Appl. No. 09/778,375
Atty. Docket No. 8414Q
Amdt. dated July 15, 2003
Reply to Office Action of April 15, 2003
Customer No. 27752

REMARKS

Annotated Sheet Showing Changes

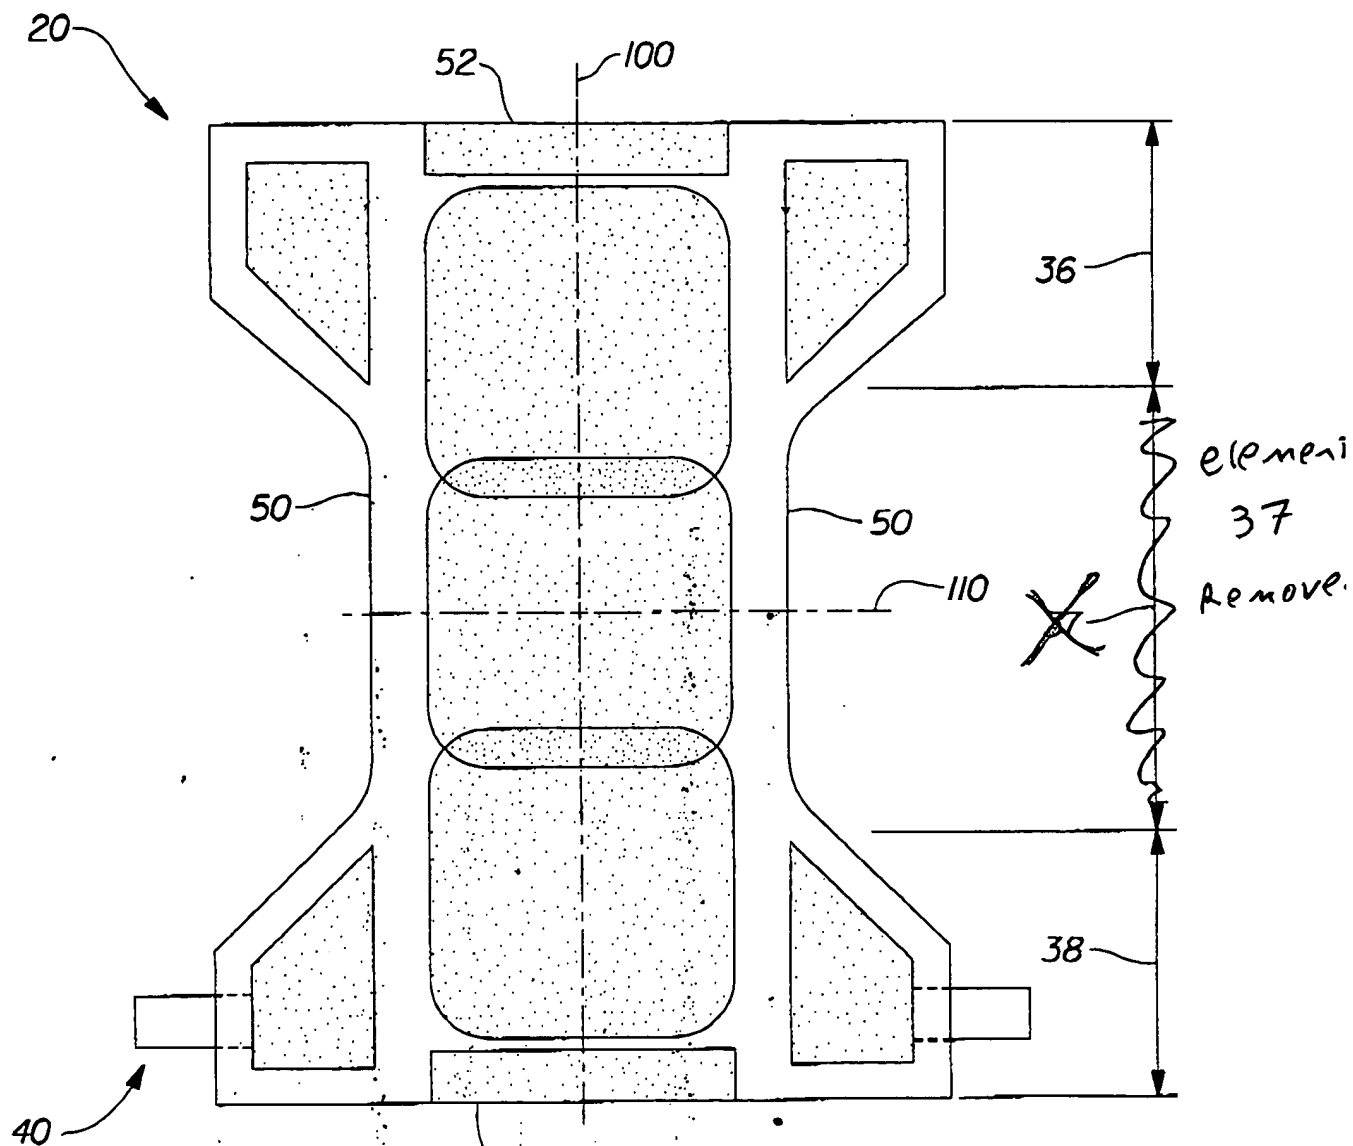
~~54~~ Reference numeral
Fig. 2 52 redesignated 54

Fig. 4

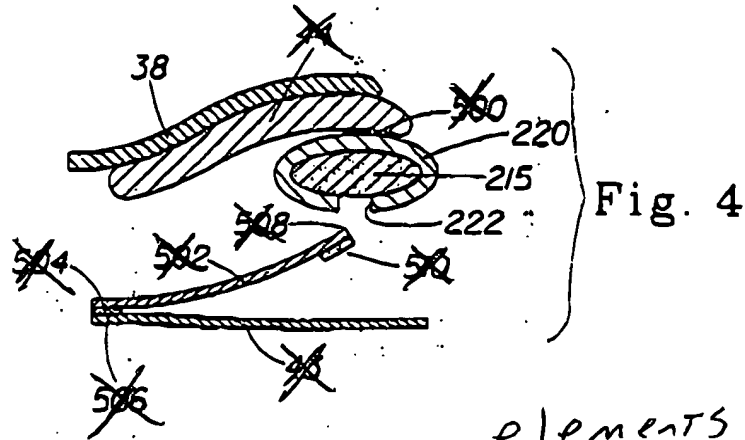
elements

500, 502, 504, 506, 508,

510, 43 and 44

have been removed

Fig. 5

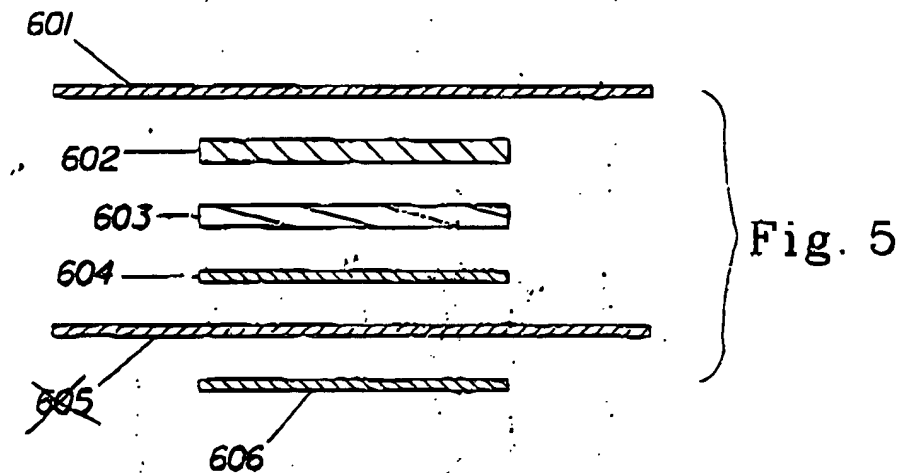
Element 605 has been
removed
